SITE PLAN APPLICATION

Name of Proposed Development Park Ave Cleaners Expansion

File No. 94-31-9P

94-31-SP A request from Danny Murphy for a Site Plan for an addition to Park Ave. Cleaners located at 2910 Ridge Road.

SITE PLAN

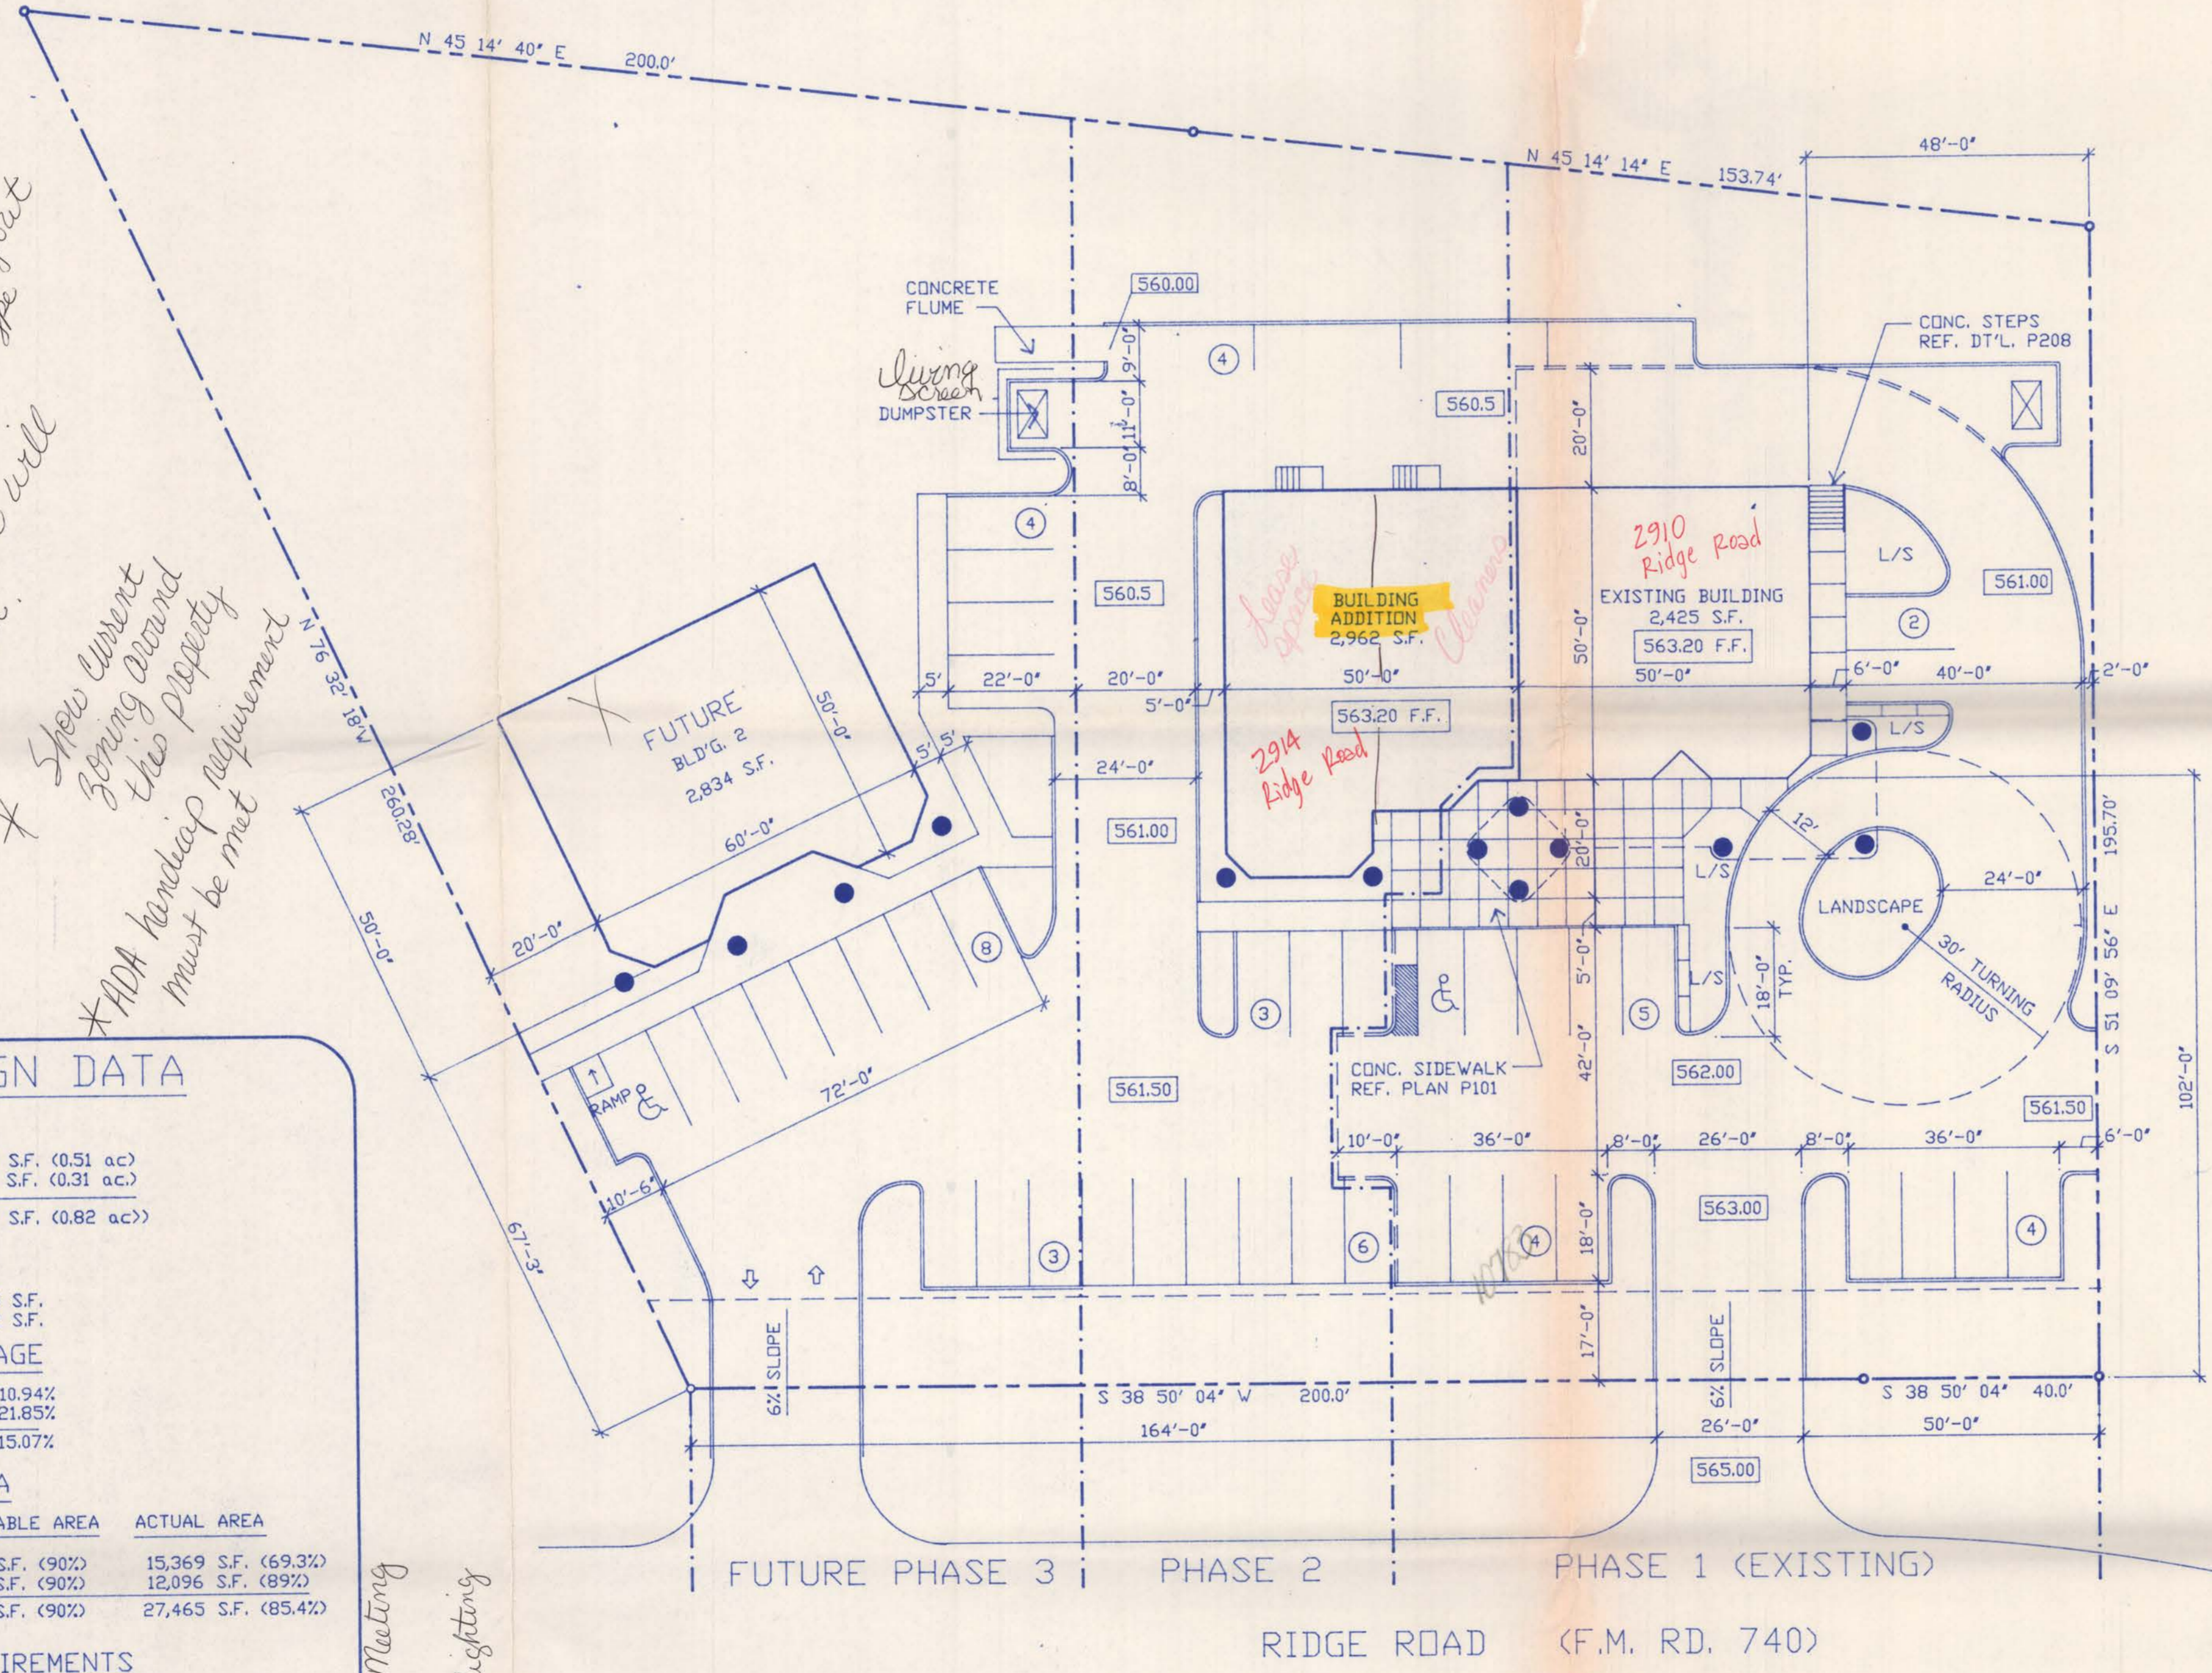
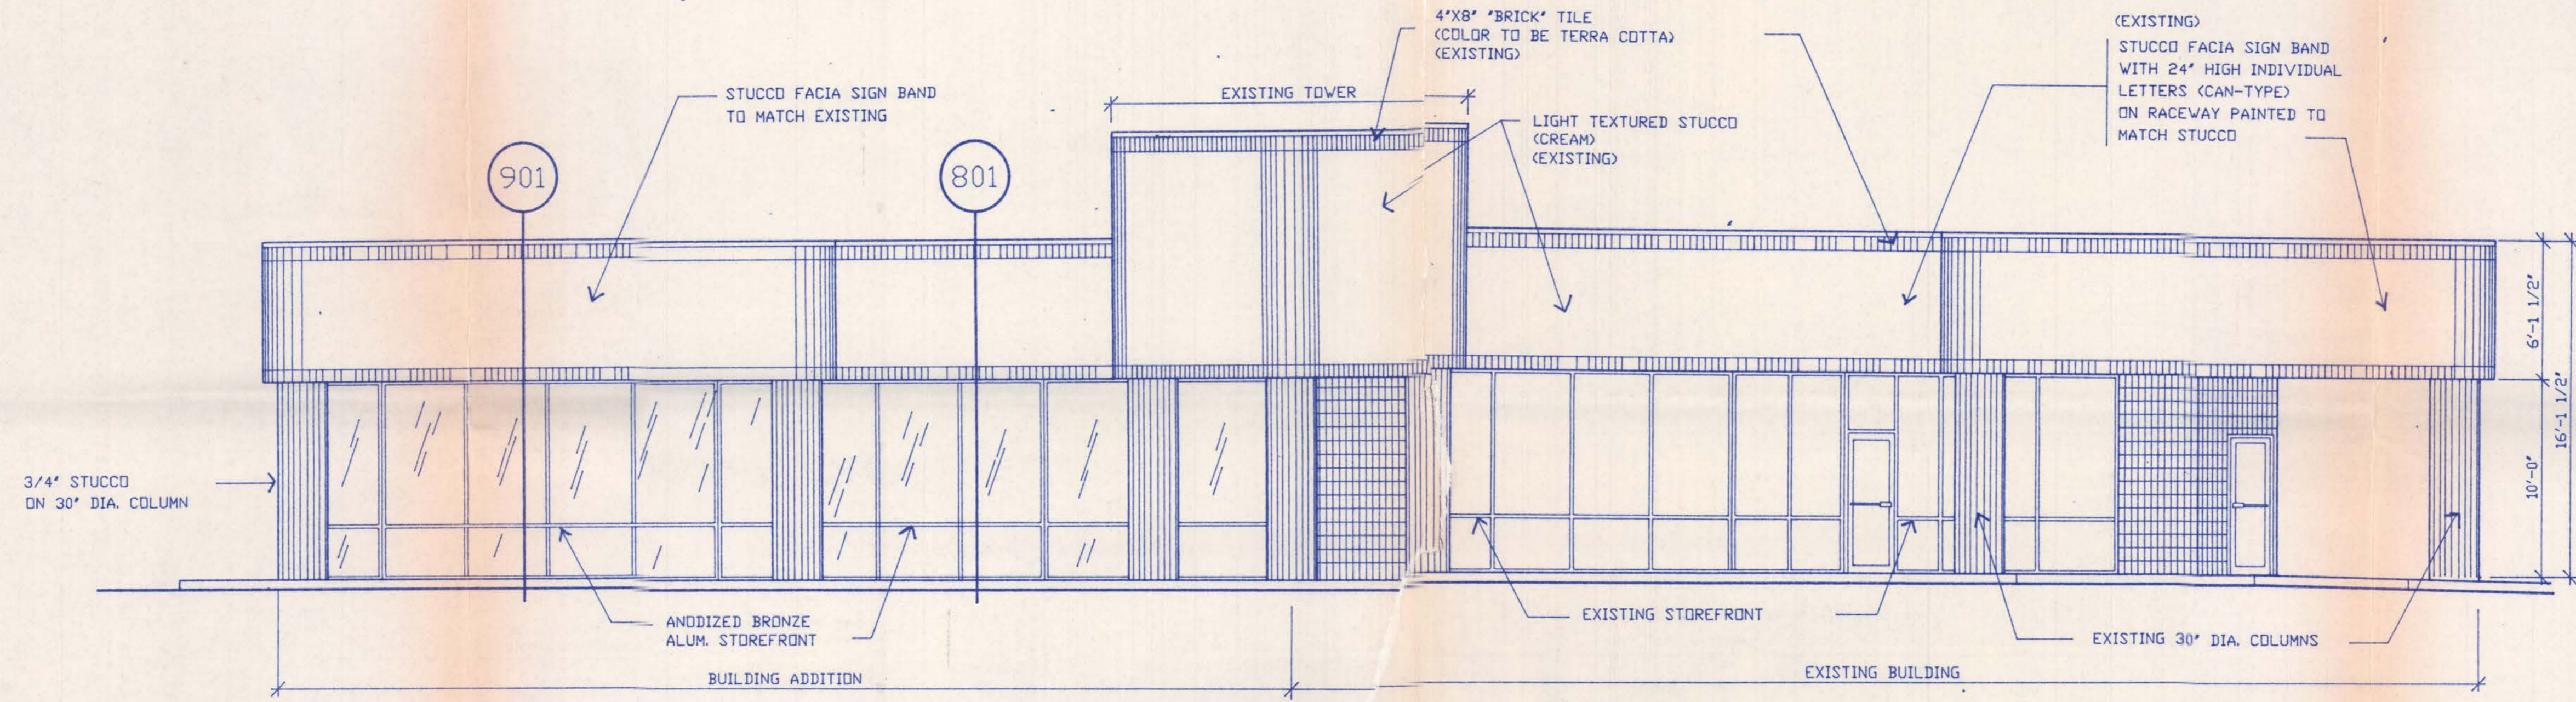
* Topsoil
 * Legal description
 * Will need landscape layout
 * How dumpster will be shown.
 * Show current zoning
 * ADA handicap requirement must be met

ARB Meeting
 No parking lot lighting

zoned "GR"

Mr. Douphrate outlined the request recommending approval of the site plan provided the applicant indicate the zoning on the adjacent properties surrounding this development.

The site plan indicates the zoning on the adjacent properties surrounding the development.

The legal description on the site plan include only the platted property.

A separate instrument for cross easement access be include.
